To: LFEVY42016 Team
From: Geoff Nudge
Date: 5/9/2016
Subject: Accumulator Errata

This memo lists all known errata regarding the TSV accumulator. Suggestions are made to correct these items.

PACK VOLTAGE SENSOR AND CHARGE SENSOR

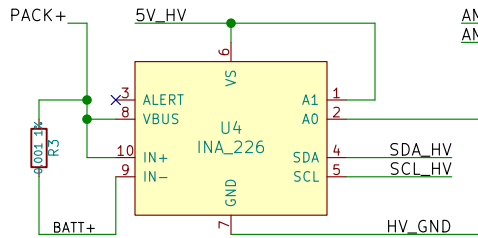
I2C Address 0x44 (see datasheet page 18) Additional documentation of the use of this component is req'd.

I2C ISOLATOR

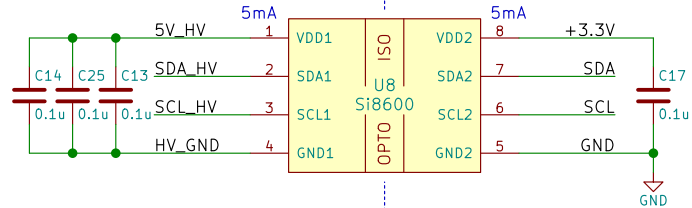
The flyback regulator responsible for delivering 5V isolated power to low voltage systems has been replaced with an isolated DC/DC converter. This is due to the insufficient output current (300mA) available when assembled. Cost is comparable.

Maximum Current Draw on 5V output: 1.2A

This zener diode is not needed now that the flyback converter is not being used.

CAN TRANCEIVER

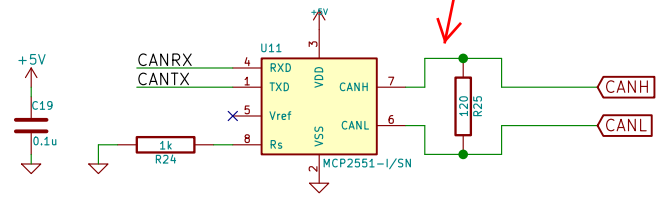
A zener diode and CAN resistor should never be populated (see attached annotated schematic).

NEVER
POPULATE

NOTE: DO NOT populate R26.

R26 provides the ability to use this board
as a terminating CAN node in development only.

Spring 2016		
Supervisor: Chris Nadovich		
Engineer: Geoff Nudge		
Lafayette College ECE		
Sheet:		
File: pacman-main.kicad_pcb		
Title:		
Size: A4	Date: 2016-03-16	Rev: 0.4
KiCad E.D.A. kicad 4.0.2-4+622538ubuntu14.04.1-stable		Id: 1/1

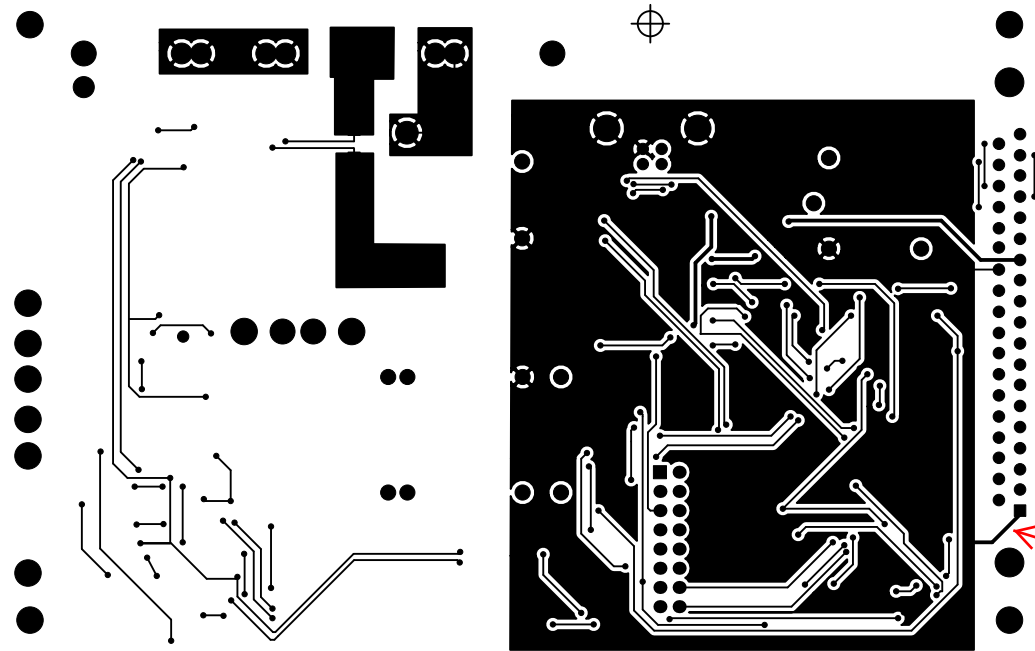
CAN GND should not be connected to PacMan ground plane (see attached annotated schematic).

This connection between CAN GND and the ground plane should be removed.
